QLDC STATEMENT FOR HEARING – 26 August 2025

In the Matter of: Mount Iron Junction Housing Scheme (FTAA-2602-1173)

Topic: Active Transport, Pedestrian, and Cycle Linkages

Figure 1: Active Transport Links Plan

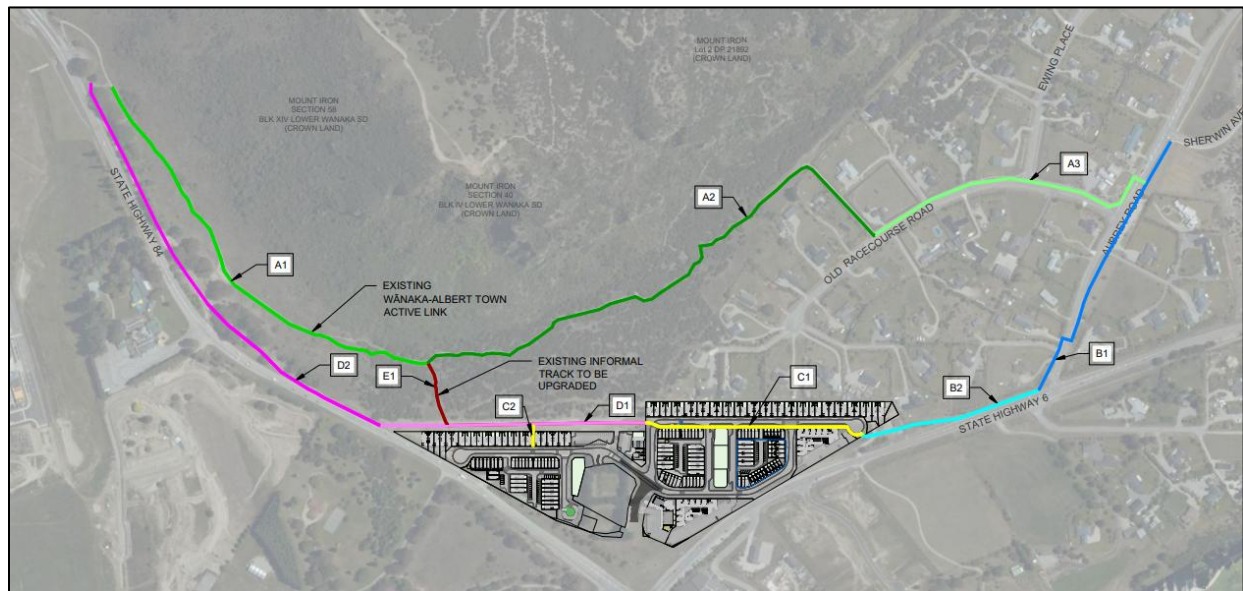
- path widths,
- lighting, or
- additional connectivity to the north and east of the site via B1 and B2 (shown in blue) which should be provided and funded by the applicant.

While the applicant has proposed a 3m wide path for Section D1, they have offered a reduced width of 2.5m for Section D2, which is the westernmost and longest link in the path network, connecting to Three Parks. QLDC's preference is that Section D2 is also formed to a full 3m width.

QLDC's stance remains that the entirety of the shared use path network must be lit – that being all of D1, D2, C1, and C2. The applicant's current proposal does not demonstrate adequate lighting, stating that paths will be unlit apart from areas where lighting exists or is required for the new roading network. The justification for all paths to be lit is:

QLDC strongly objects to this barrier and the lack of northern connectivity. Rather than improving connectivity, this approach actively eliminates active travel opportunities and will mean pedestrians and cyclists heading south from Albert Town are forced to ride adjacent the highway for a longer distance. We maintain that the active travel link must extend eastwards and northwards from the site (shown as B1 and B2) to establish a safe connection to Aubrey Road. The rationale for this connection includes:

QLDC opposes the applicant's proposed condition to defer the construction of these paths until the subdivision stage that includes the 50th residential unit. In QLDC's view, the paths should be delivered prior to the occupation of any residential or commercial element of the development to ensure active transport infrastructure is available from the outset.

- Section D2 of the shared path be widened to 3.0m to ensure safe, two-way commuter flow;
- Lighting be required along the active travel network to guarantee safe, year-round use and encourage modal shift;
- The physical barrier at Junction Road be rejected in favor of a dedicated active transport link and B1/B2 be constructed at the applicants cost; and

- i. *The path shown as D1 **and D2** shall be constructed to an ~~unlit~~ 3m sealed formation width (drawing B5-22 or B5-23 or NZTA equivalent). This path shall be constructed ~~as part of, or prior to, the stage of the subdivision that includes the 50th residential unit.~~ **prior to occupation of any residential unit and prior to the operation of retail activities in the new retail building, the childcare facility, and the café.***

- iii. ***The path shown as B1 shall be constructed to a 3m sealed formation width (drawing B5-22 or B5-23 or NZTA equivalent). This path shall be constructed prior to occupation of any residential unit and prior to the operation of retail activities in the new retail building, the childcare facility, and the café.***

- iv. The path shown as B2 shall be constructed to a 3m sealed formation width (drawing B5-22 or B5-23 or NZTA equivalent). This path shall be constructed prior to occupation of any residential unit and prior to the operation of retail activities in the new retail building, the childcare facility, and the café.
- q) The active travel network shall be appropriately lit through the use of bollards, with a lighting plan to be provided to Queenstown Lakes District Council for certification prior to construction.
20. ~~The consent holder shall provide the consent authority written confirmation of approval from the NZ Transport Agency that the design of the active transport links is in accordance with the applicable NZ Transport Agency design standards.~~
